Appendix A.2 – Environment Agency Correspondence

Our ref: KT/2020/127776/01-L01
Your ref: 2813/KT
Date: 13 January 2021

ENVPAC/1/KSL/00360

Custom House, The Terrace, Gravesend, DA12 2DE

EA Requirements - Proposed Sections

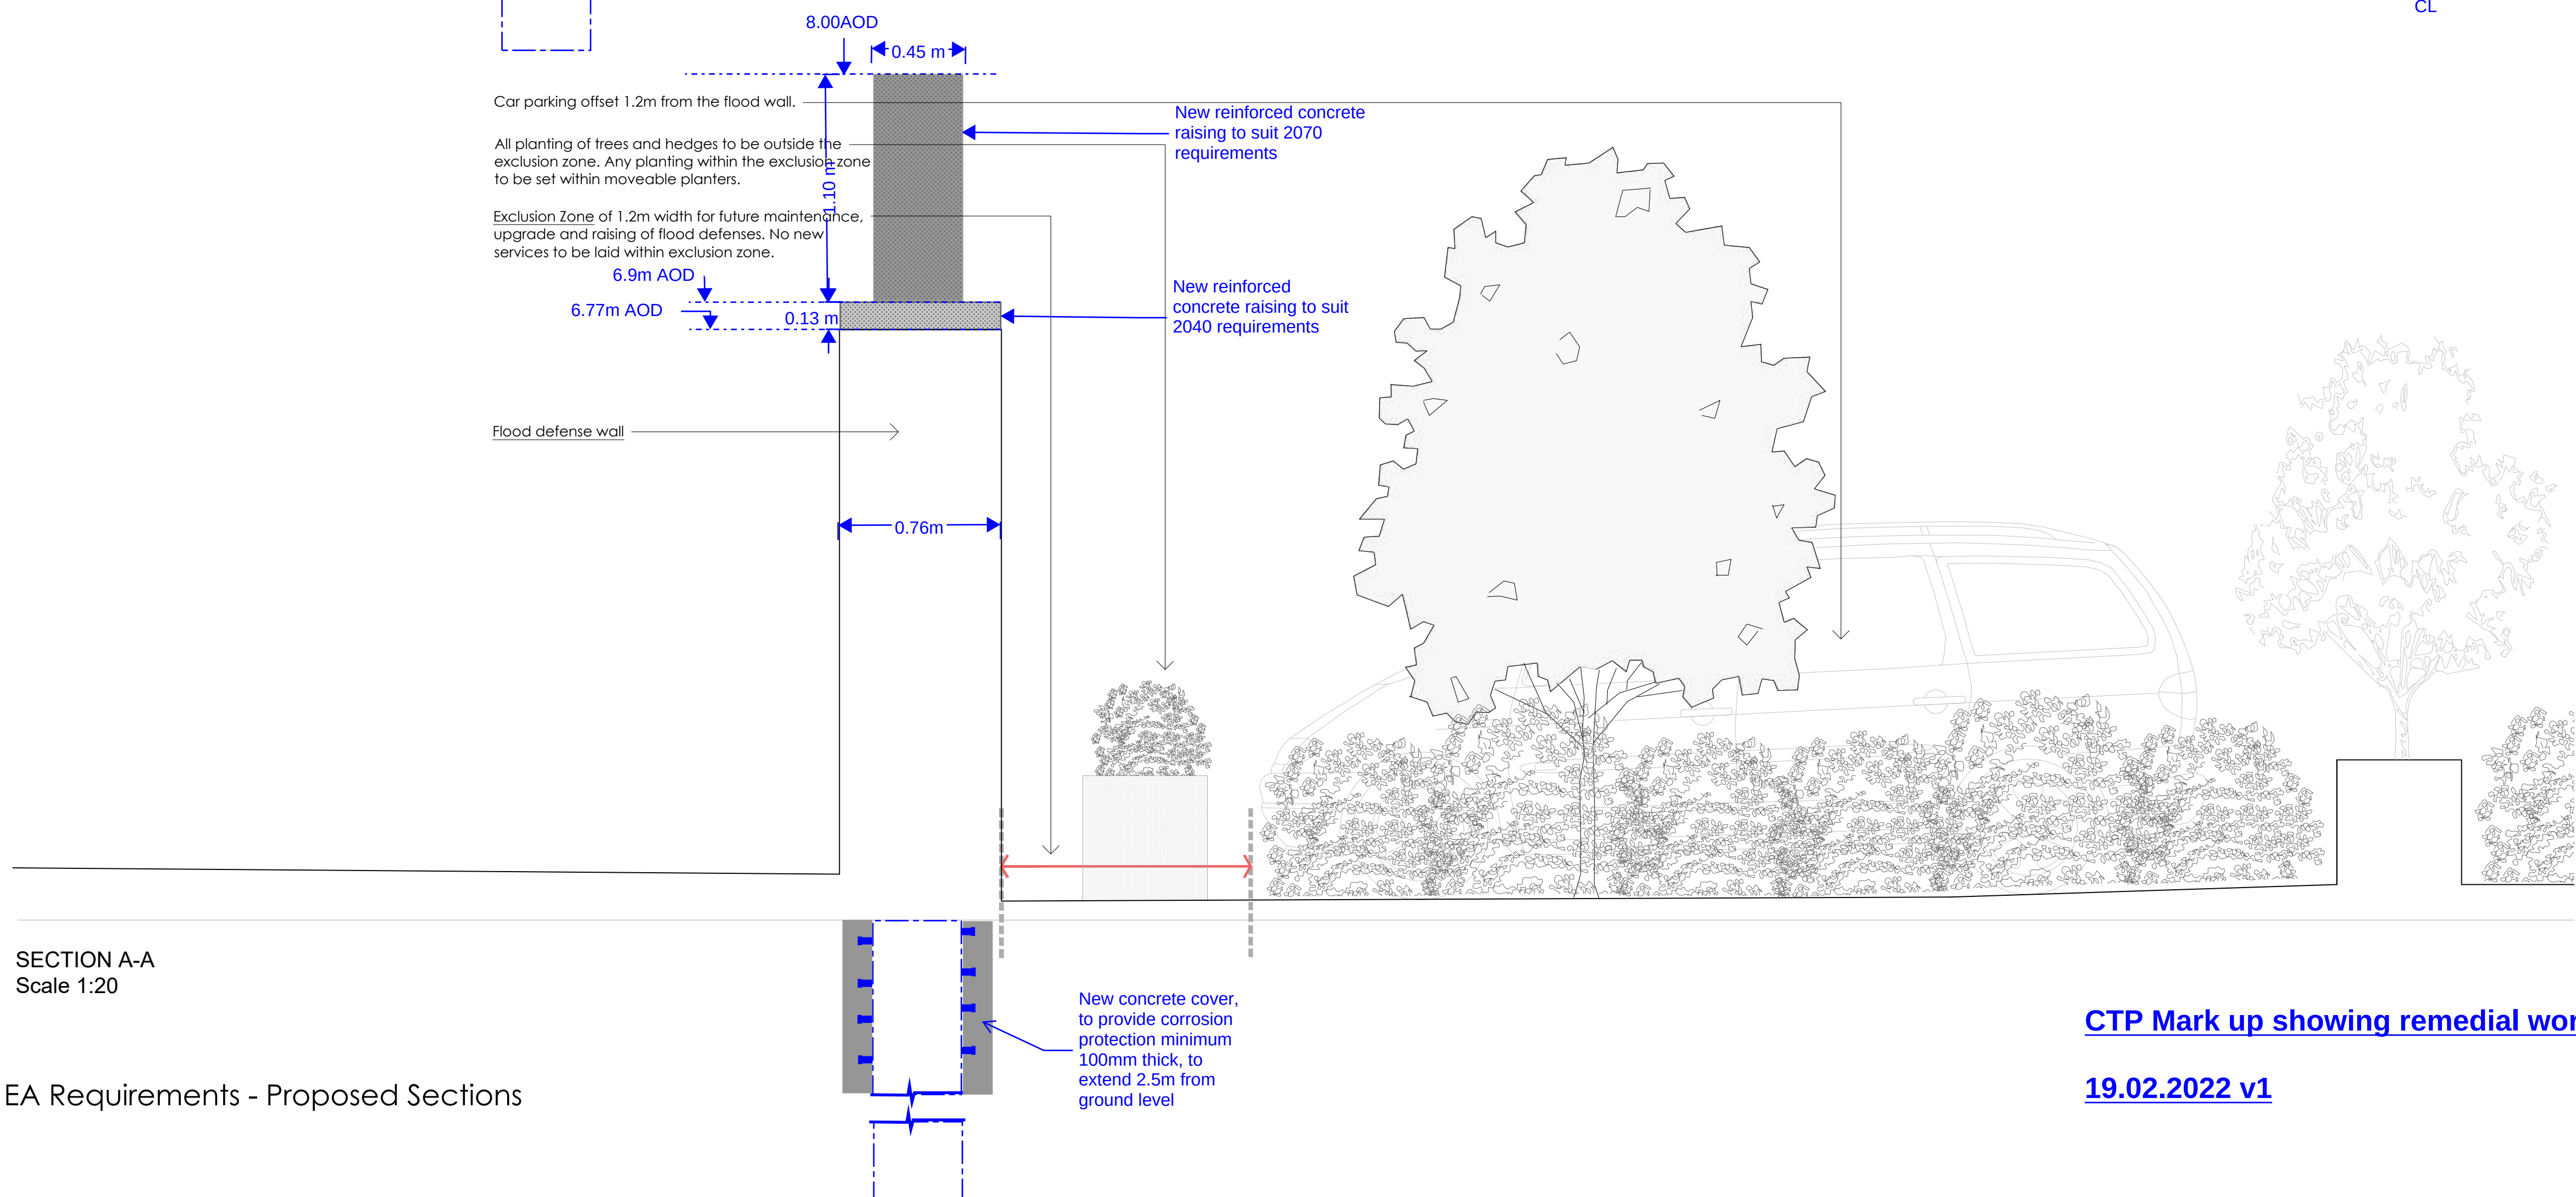
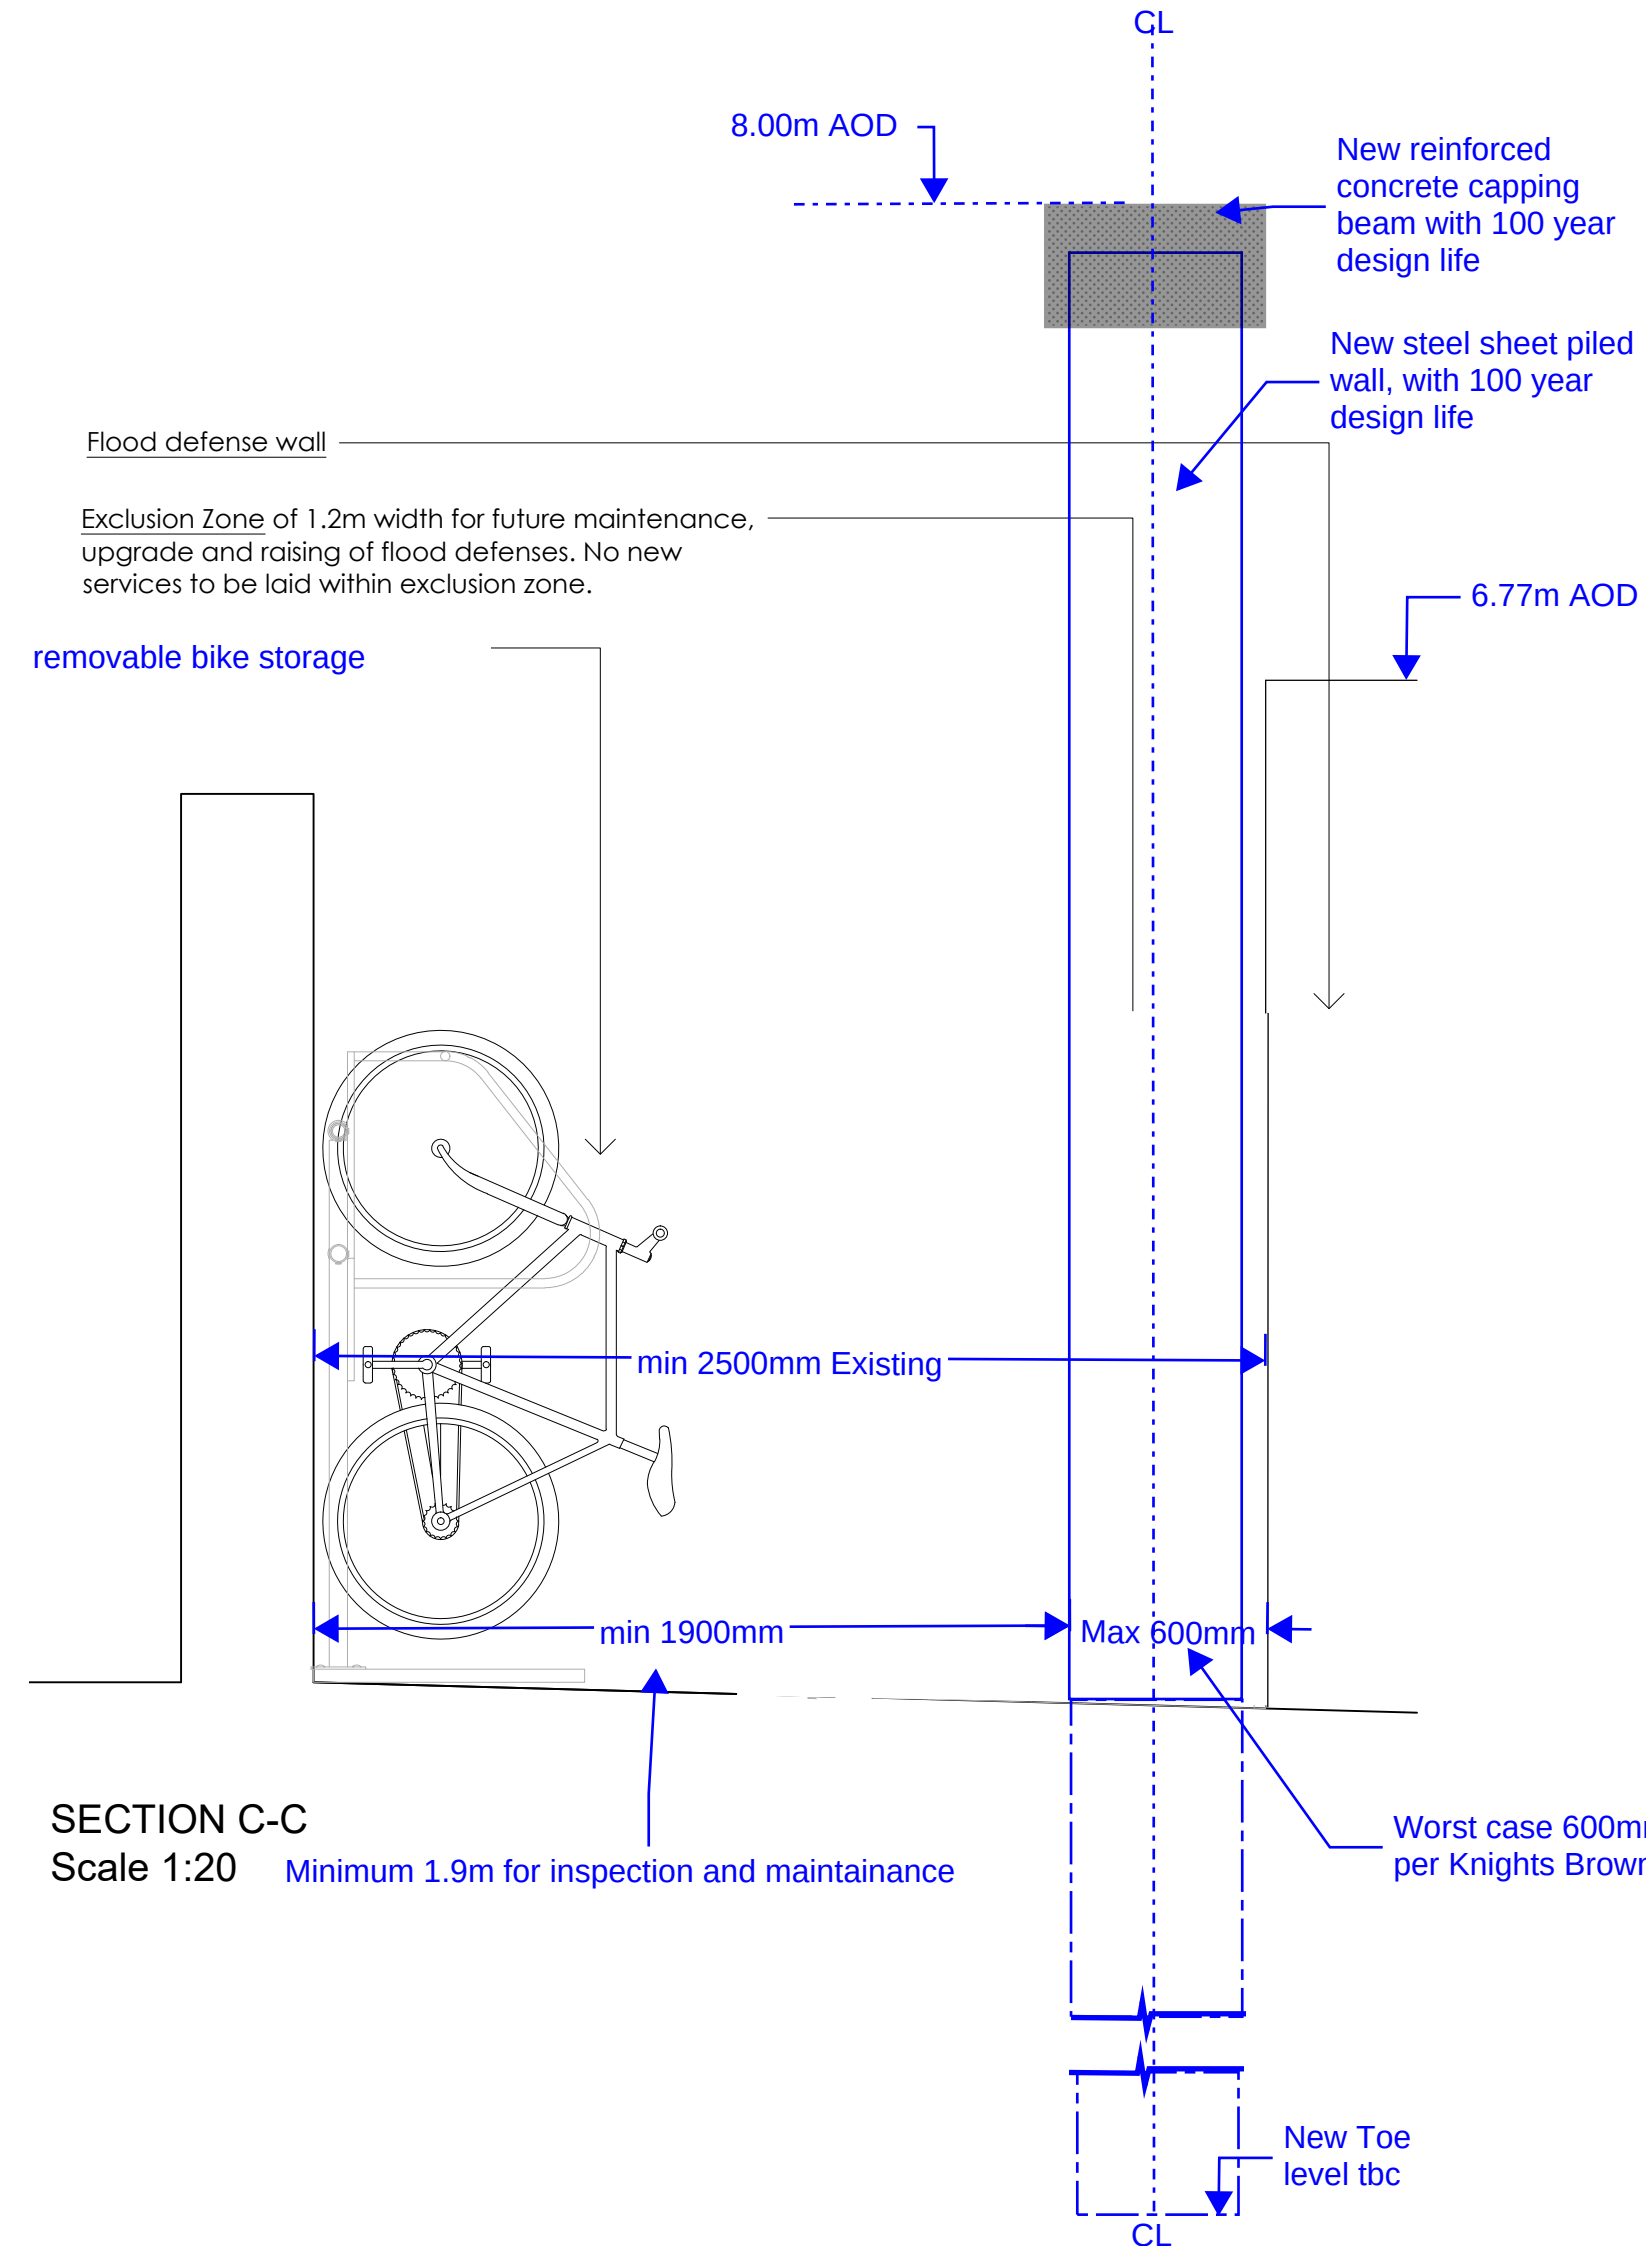
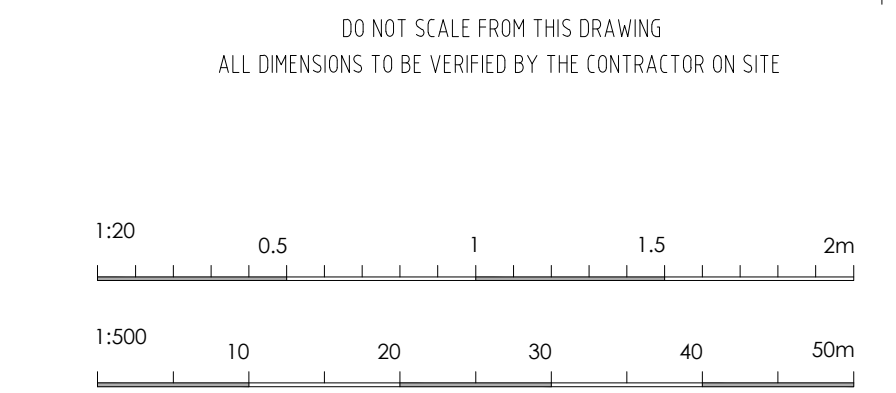
- The 'Proposed Site & Lower Ground Floor Plan EA Requirements Drawings' indicates that the stairs will remain in place over the flood defence. Note, if the stairs are removed/replaced we would require the necessary raising (2070) to be completed underneath the stairs to avoid undue cost and difficulty in the future.

- It has not been confirmed in the report how the floodgate will be decommissioned as part of the development, but the drawing suggests it would be sealed. This option is a temporary decommission and requires

4.2 Following the feedback received, the floodgate will be replaced with a new reinforced concrete wall. This will be tied into the surrounding structure, designed for a minimum of 100-year design life. Refer to the drawing in Appendix A for the marked-up plan, along with the buildability statement contained in Appendix D.
